Ultra Electronics SERVICE BULLETIN

SERVICE BULLETIN No. C8E38-75-001

ENGINE AIR - COMPRESSOR CONTROL - BLEED VALVE CONTROL

INTRODUCTION OF BVCU TYPE NUMBER C8E38-12

Location of Motherboard Links
Figure 1

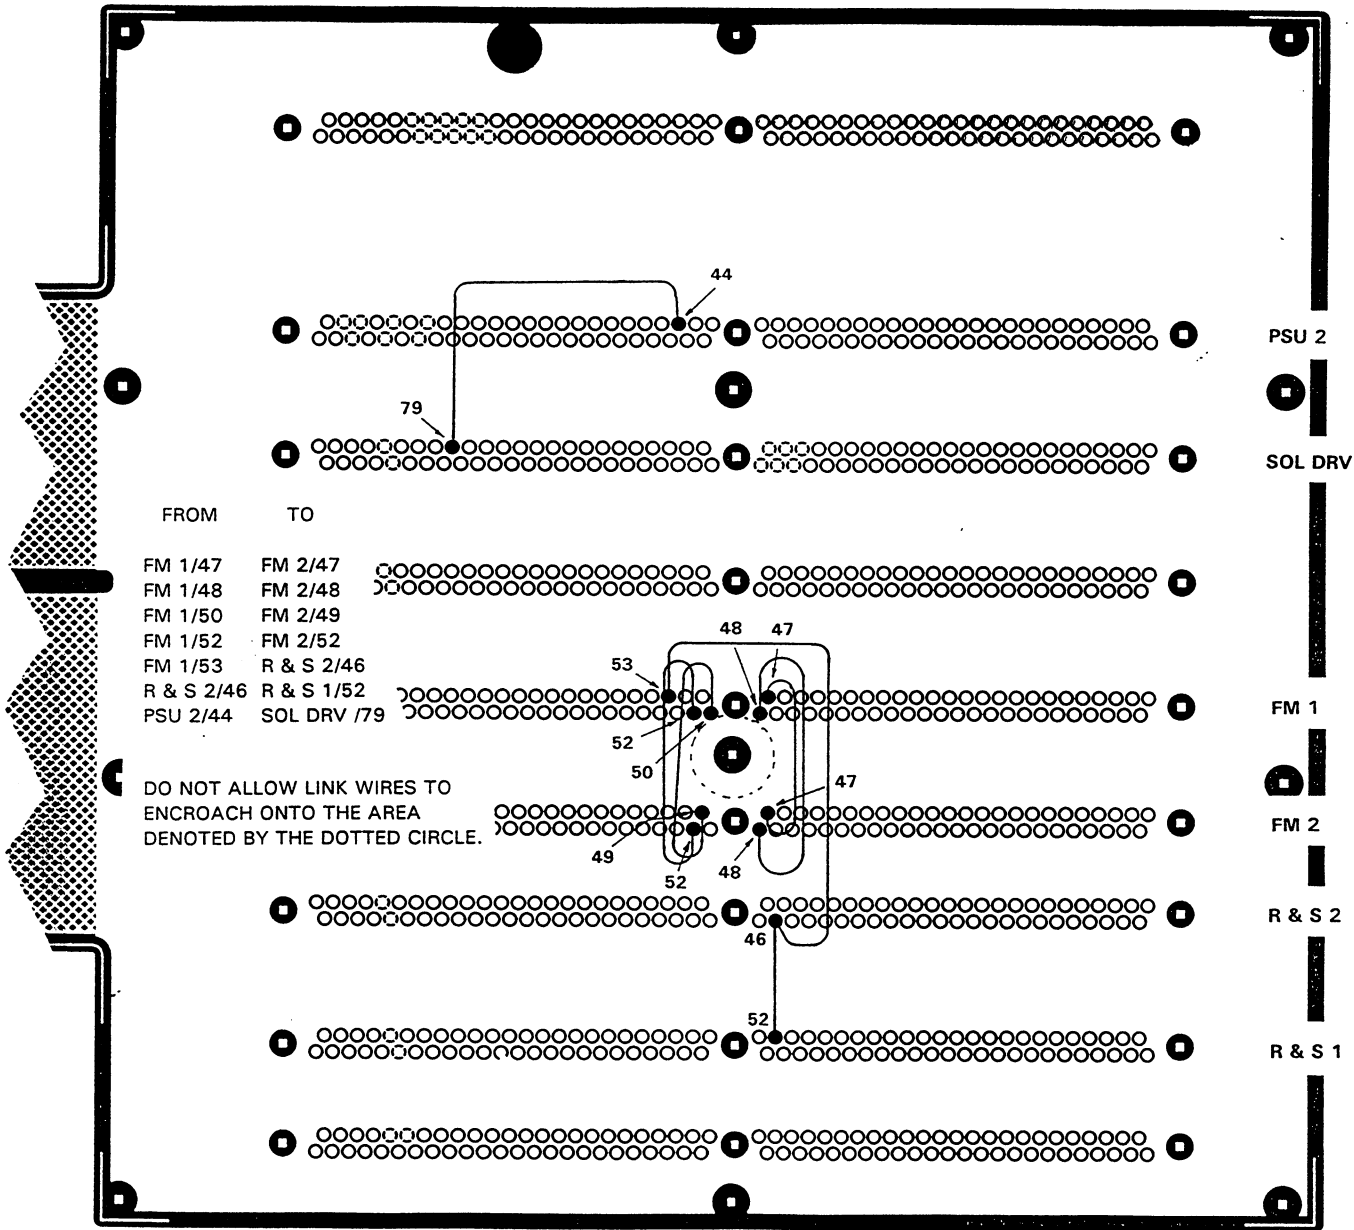
- (1) Refer to Fig. 1 in this Service Bulletin. On the motherboard, locate and identify the pin connections listed in the table in Fig. 1.
 - (2) Refer to CMM 75-32-02, Repair page 601 and up, and familiarise yourself with the procedures for soldering work on conformally coated boards.

- (3) After removing the conformal coating locally around each pin connection, make up a set of links using Raychem Type 44, 7/0.0063 wire, Part No. 44A702926 (or its equivalent). Form the stripped ends of each link into tinned hooks of a size to fit over the protruding connector pins.

- (4) Solder the links to the connector pins, ensuring that a good fillet of solder is formed around each hook.
 - (5) Using Dow Corning adhesive RTV 3145 (or its equivalent), tack each link to the motherboard surface at frequent intervals.
